Design Recommendation Meeting  
6.22.2020  
3033617-EG  
3034294-LU  
809 S Washington St

# EDG RESPONSE

## Stormwater

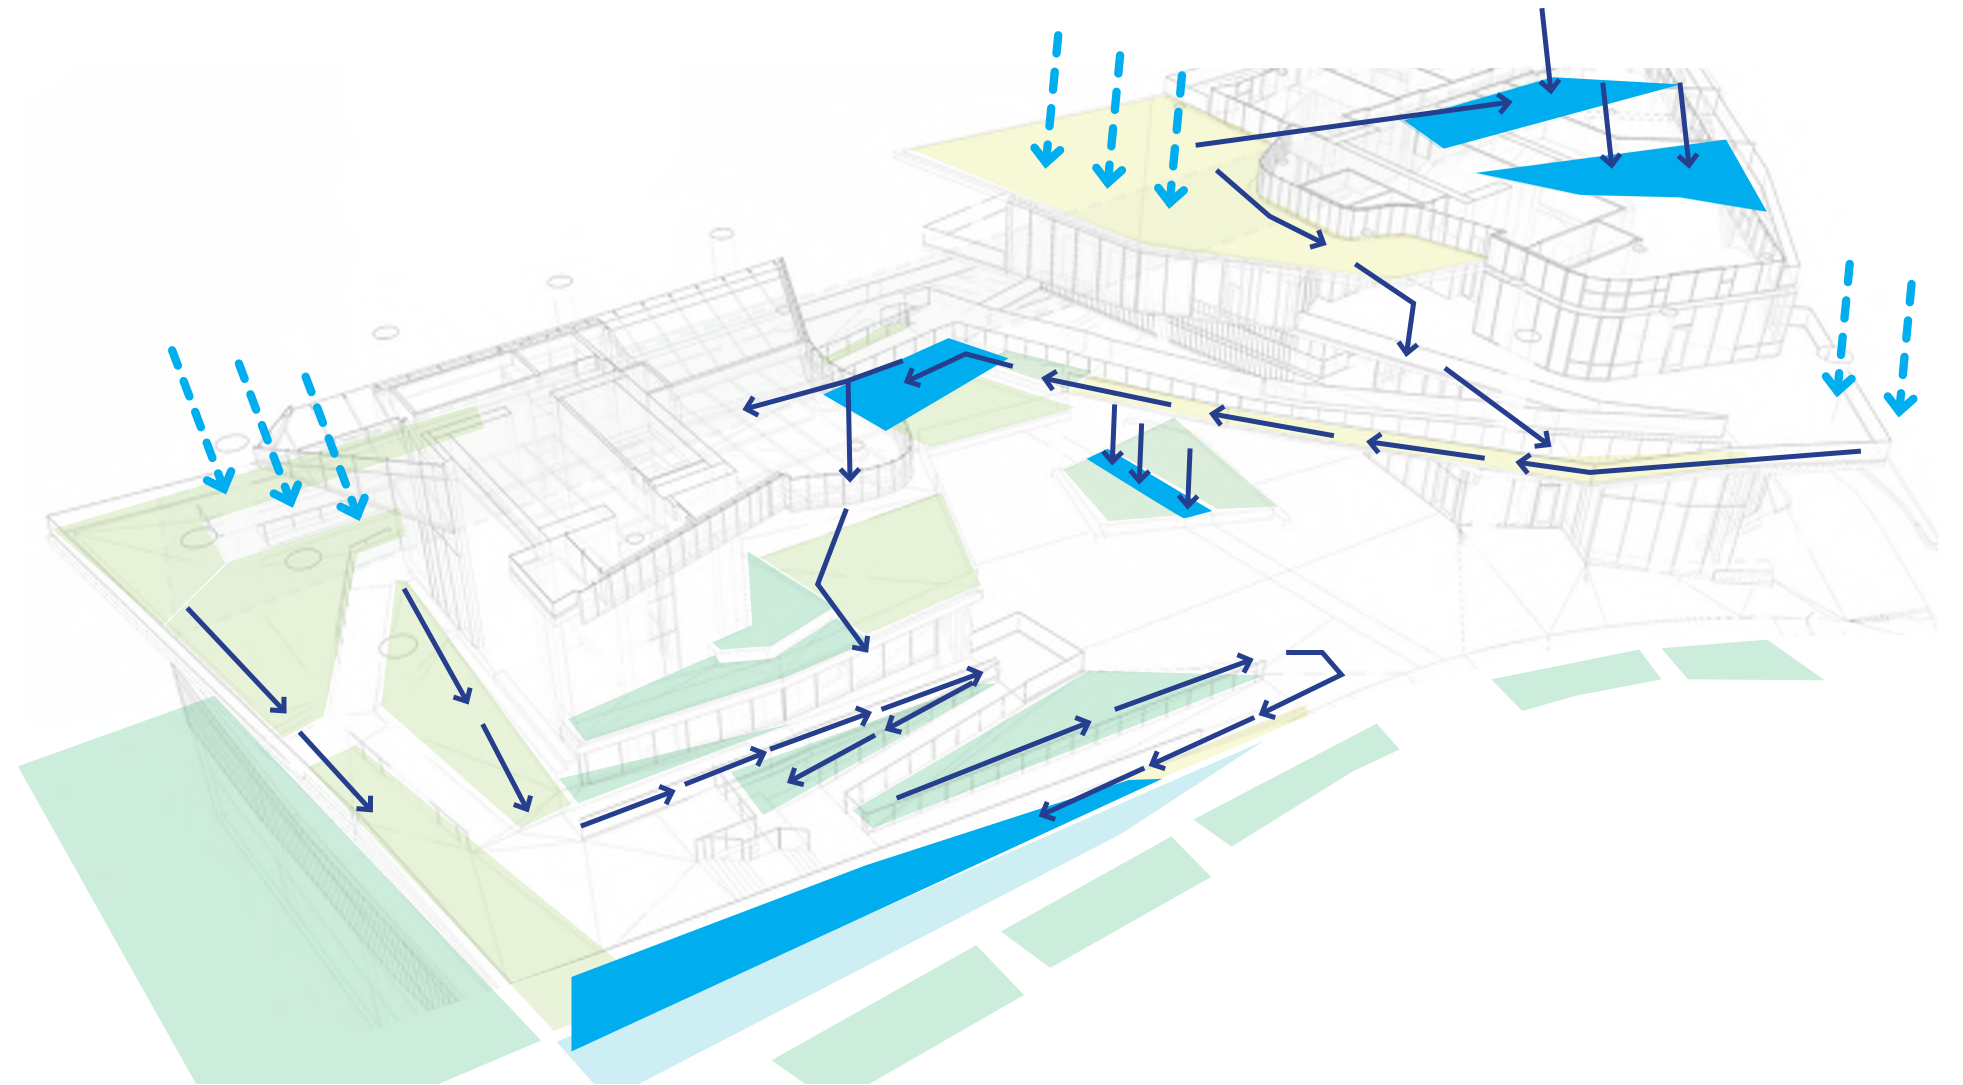
**7B. Stormwater:** The Board strongly encouraged the integration of stormwater runoff into the landscape design. The Board noted that these features should also be prominent as part of the Phase I development. (Yesler Terrace DC4 Hardscape Materials)

Phase 1 Development: Pedestrians will access the west edge of the site from Yesler Way via the wide accessible bridge over the bio-retention planter that introduces the on-site stormwater strategy along the edge of the public sidewalk.

Phase 2 Development: A corresponding linear bio-retention planter along the east side of the site immediately adjacent to the public sidewalk will provide visible cues to the stormwater while providing a lush evergreen edge to the structure that rises to the elevated open spaces. The elevated open spaces incorporate rainwater runnels along the pedestrian ramps and walkways to allow rain events to be experienced as apart of the winding sequence that begins at Level 3 and meanders down to the plaza level and the on-grade site entrance. See diagram for site water elements.
